Work Order ID 133609

Item Name: Crosstube Turning Detail

DRAWING NO. D407-667-145	TITLE CROSSTUBE ASS'Y (407 HIGH FWD)	REV. C	DART AEROSPACE LTD ENGINEERING ORDER		D.E.O. NO. D407-667-145-C-1	SHEET NO. SHEET 1 OF 1	SCALE NTS
DRAWN 92	CHECKED ASS	MFG. APPR. IB	APPROVED WD		DE APPR. H		
DATE 11.07.15	DATE 11.07.22	DATE 11.07.22	DATE 11/07/22		DATE 11.07.21

DRAWING NO. D407-667-145	TITLE CROSSTUBE ASS'Y (407 HIGH FWD)	REV. C	DART AEROSPACE LTD ENGINEERING ORDER		D.E.O. NO. D407-667-145-C-2	SHEET NO. SHEET 1 OF 1	SCALE NTS
DRAWN AJS	CHECKED	MFG. APPR. <i>E</i>	APPROVED <i>AP</i>	DE APPR. <i>AP</i>			
DATE 12.08.02	DATE 12.08.02	DATE 12.08.02	DATE 12.08.02	DATE 12.08.02	DATE 12.08.02

DETAIL P
BONDING STRAP INSTALLATION 2 PL

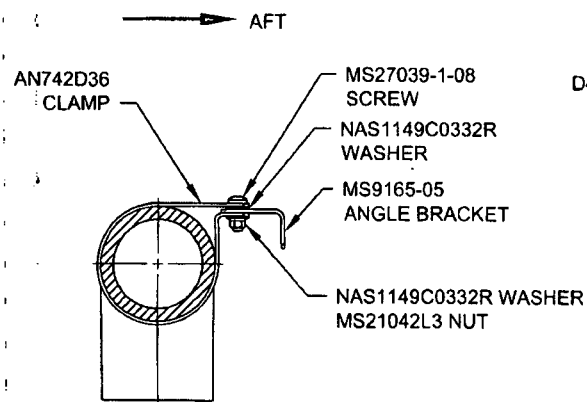
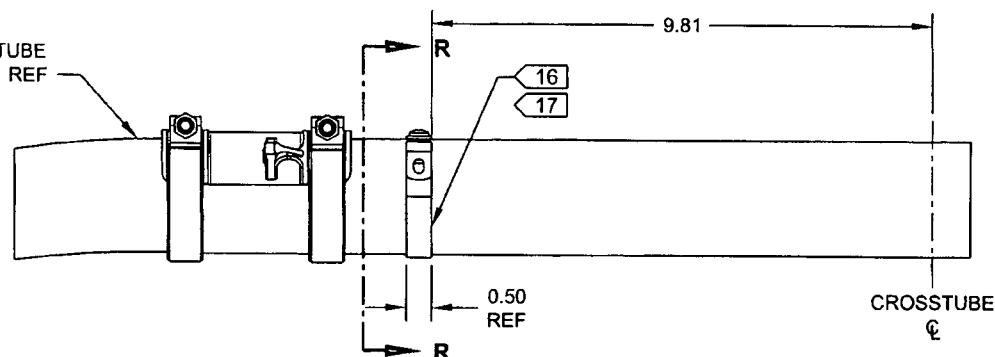
PURPOSE:

ADD ELECTRICAL GROUNDING STRAP

ITEM	QTY -145	PART NUMBER	DESCRIPTION
1	X	D407-667-145	CROSSTUBE ASSEMBLY (407 HIGH FWD)
⚡			
10	2	AN742D36	CLAMP
11	2	MS9165-05	ANGLE BRACKET
12	2	MS21042L3	NUT (OR MS21042-3)
13	2	MS27039-1-08	SCREW
14	4	NAS1149C0332R	WASHER (OR AN960C10L)

- 16) MASK AREA UNDER CLAMP PRIOR TO PAINTING
- 17) SEAL EDGES WHERE AN742D36 CLAMP MEETS WITH THE CROSSTUBE USING SIKAFLEX-241/-291 OR MIL-S-8802 CLASS B2 OR PROSEAL 890 SEALANT
- 18) PERFORM RESISTANCE CHECK TO ENSURE MAX RESISTANCE IS 10 MILLIOHMS
